# Hamblin Pond and Bathhouse

Town of Barnstable  
ADA Transition Plan

August 2021

Institute for Human Centered Design

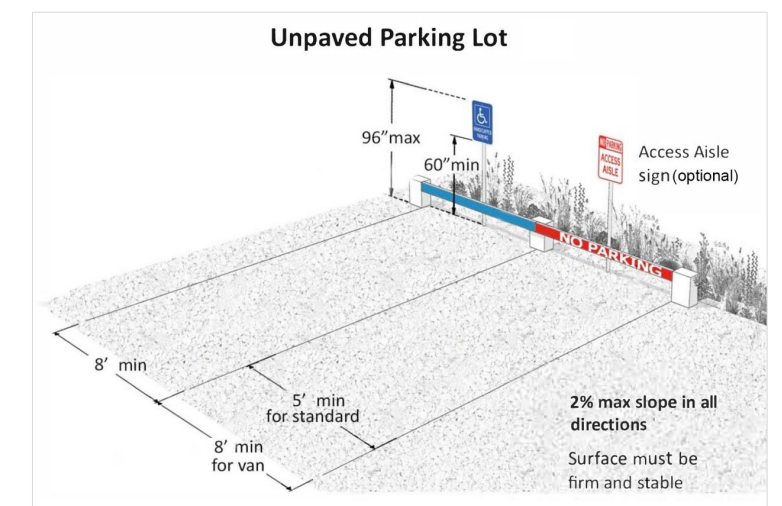
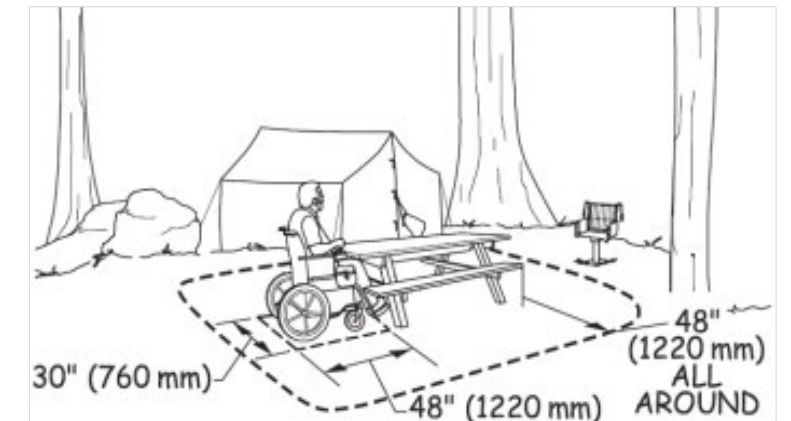
4	Parking Lot	Ext.		Off-Street Parking Lot or Garage	Visitor		Total # of designated van accessible spaces Surface not stable, firm, and slip-resistant	-	Provide a van accessible spaces that is at least 96" wide with a marked access aisle that is at least 96" wide. Ensure slope is not steeper than 1:50 (2.00%) in all directions. Add the designation "Van Accessible" to the sign. Repair surface. (See sketch for possible design of the parking space.)	1	1850	\$1850
<b>Access to Goods and Services</b>

Possible accessible route

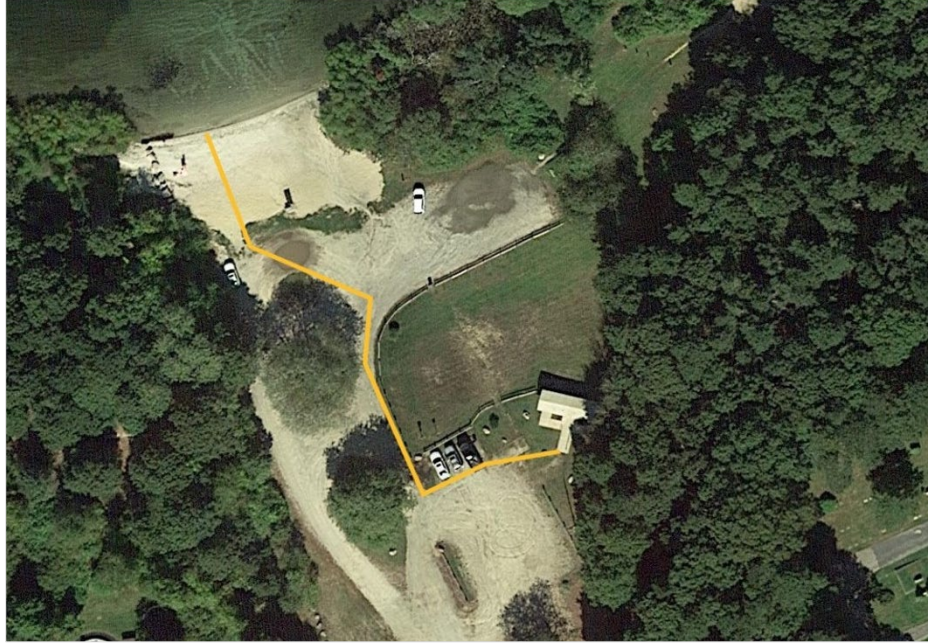
- Ramp to the bathhouse is not connected to an accessible route.
- Parking lot lacks a van designated parking space (see drawing for possible van accessible parking space design).
- Route around the pond is not firm and stable.
- Accessible route to the recreation water level at the pond is not provided.
- Maneuvering clearance at the toilet is slightly narrower than allowed due to the location of the urinal and dispensers protrude into the circulation path.
- Picnic table is not accessible.
- Designation signs lack raised characters.

- Provide an accessible route that connects all amenities at the pond: \$5,792
- Provide an accessible route to the recreation water level at the pond (beach mat): \$3,899
- Miscellaneous corrective actions (parking, signage, picnic table, etc.): \$3,970
